<p>Addendum No. 1</p> <p>City of Coquitlam Tender 85262 Saddle Street Sanitary Upgrades Issue Date: July 16, 2024 (Consists of 10 Pages)</p>

Revisions

Contract 85262
Saddle Street Sanitary Upgrades

Revised - APPENDIX 1 - Revision No.1
FORM OF TENDER

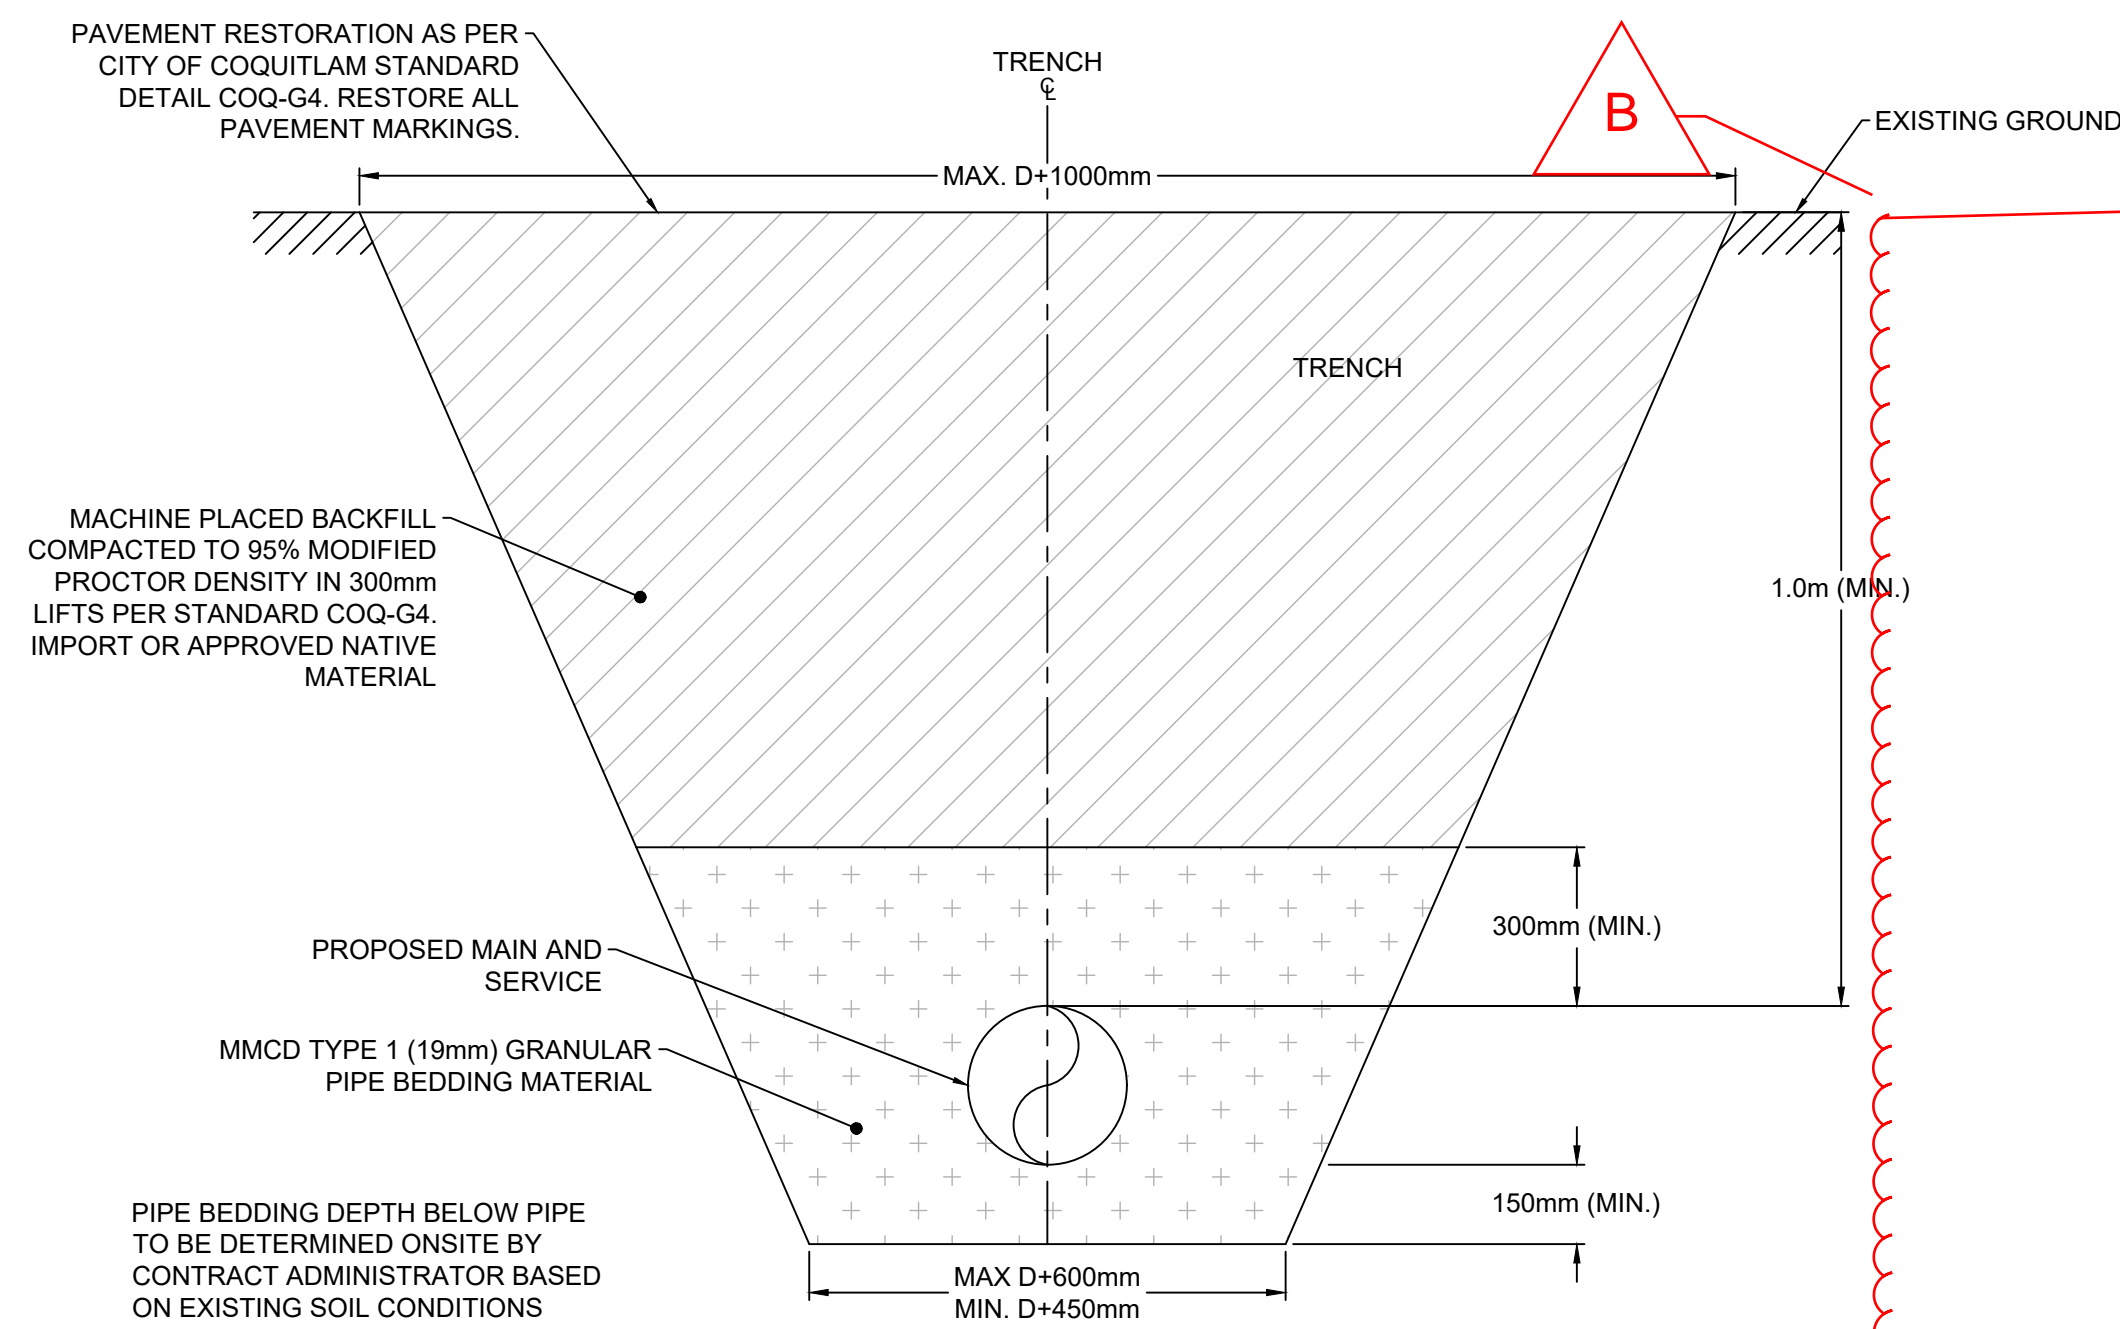
1. Refer to: FORM OF TENDER

REMOVE: Appendix 1

REPLACE with: *Revised* - Appendix 1 - **Revision No. 1**

NOTE: Revisions shown in red.

3.0	01 58 01S	PROJECT IDENTIFICATION				
3.01	(1.3.1)	1.2m x 1.2m Construction Sign	each	2		
4.0	33 05 23S	TRENCHLESS SEWER PIPE BURSTING				
4.01	(1.7.2)	250mm DR17 HDPE Pipe Bursting	lin.m	165

4.02	(1.7.2)	888 Saddle Street - 125mm dia. HDPE DR 17 Sanitary Service Pipe Bursting	LS	1		
4.03	(1.7.2)	830 Saddle Street - 125mm dia. HDPE DR 17 Sanitary Service Pipe Bursting	LS	1

4.04	(1.7.2)	850 Saddle Street - 125mm dia. HDPE DR 17 Sanitary Service Pipe Bursting - Provisional	LS	1		
4.05	(1.7.3)	Sanitary Service Transfers (incl. wye)	each	9

5.0	33 30 01S	SANITARY SEWERS				
5.01	(1.6.3.1)	821 Saddle Street - 100mm dia. PVC DR28	each	1		
5.02	(1.6.3.1)	841 Saddle Street - 100mm dia. PVC DR28 - Provisional	each	1

5.03	(1.6.3.1)	881 Saddle Street - 100mm dia. PVC DR28 - Provisional	each	1		
5.04	(1.6.4)	Inspection Chamber - COQ-S8A, COQ-S7A, MMCD S9 - Provisional	each	6

SANITARY SEWER SERVICE CONNECTION

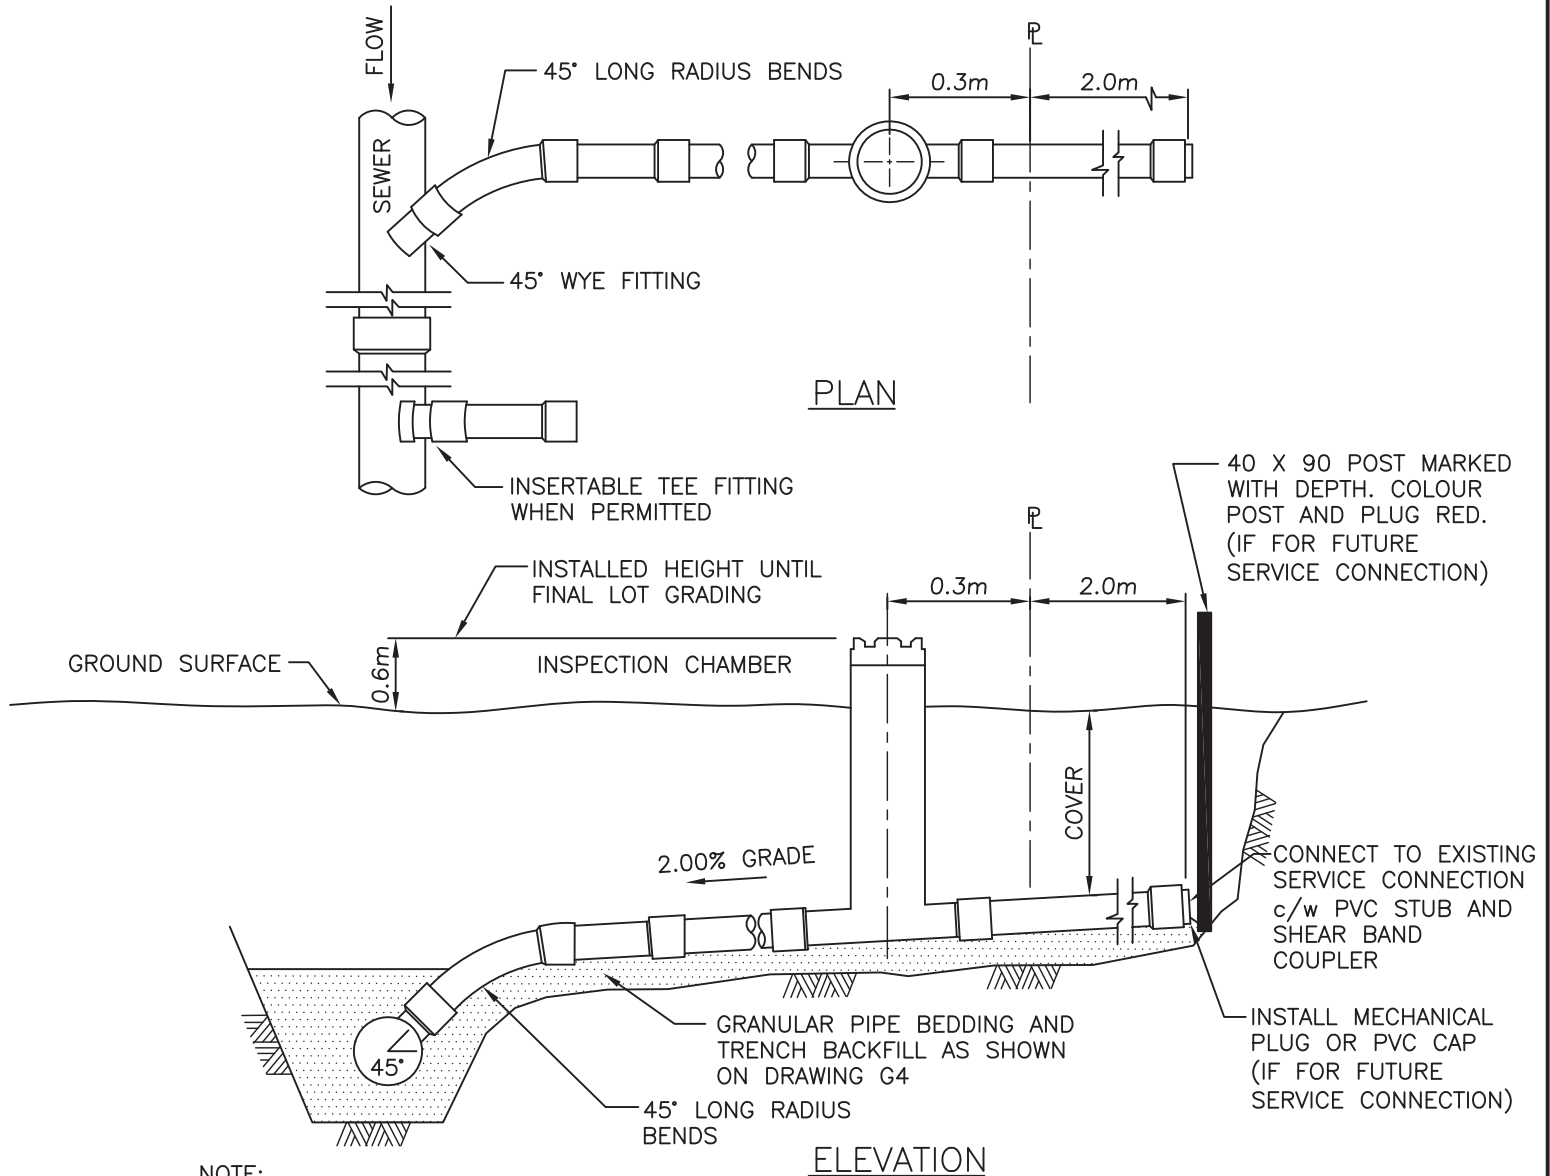
Add: Appendix B: Supplemental Detail Drawings

1. CONNECTIONS TO BE 100mm PVC SDR28 OR AS SPECIFIED ON CONTRACT DRAWINGS OR AS DIRECTED BY CONTRACT ADMINISTRATOR.
2. CONNECTION TO BE INSTALLED AT 2% GRADE FROM WYE AT MAIN TO PROPERTY LINE UNLESS OTHERWISE INDICATED ON THE CONTRACT DRAWINGS OR AS APPROVED BY CONTRACT ADMINISTRATOR. ONLY 45 DEGREE LONG RADIUS CAN BE USED FOR BENDS.

3. DISTANCE OF INSPECTION CHAMBER AND MARKER AS SHOWN OR AS SPECIFIED ON CONTRACT DRAWINGS OR AS DIRECTED BY CONTRACT ADMINISTRATOR.
4. SEE DRAWING S9 FOR DETAILS OF INSPECTION CHAMBER AND INSTALLATION REQUIREMENTS.

5. IC LID (RED COLOR) TO BE 25mm BELOW THE BASE OF SOD FINAL ELEVATION.
6. LOCATION OF INSPECTION CHAMBER AND MARKER AS SHOWN OR AS SPECIFIED ON CONTRACT DRAWINGS UNLESS OTHERWISE DIRECTED BY CONTRACT ADMINISTRATOR.

7. IN DRIVEWAYS, INSPECTION CHAMBER IS TO BE INSTALLED WITH BROOKS BOX. BROOKS BOX WITH METAL LID IS TO BE INSTALLED PARALLEL TO THE DIRECTION OF THE FLOW.
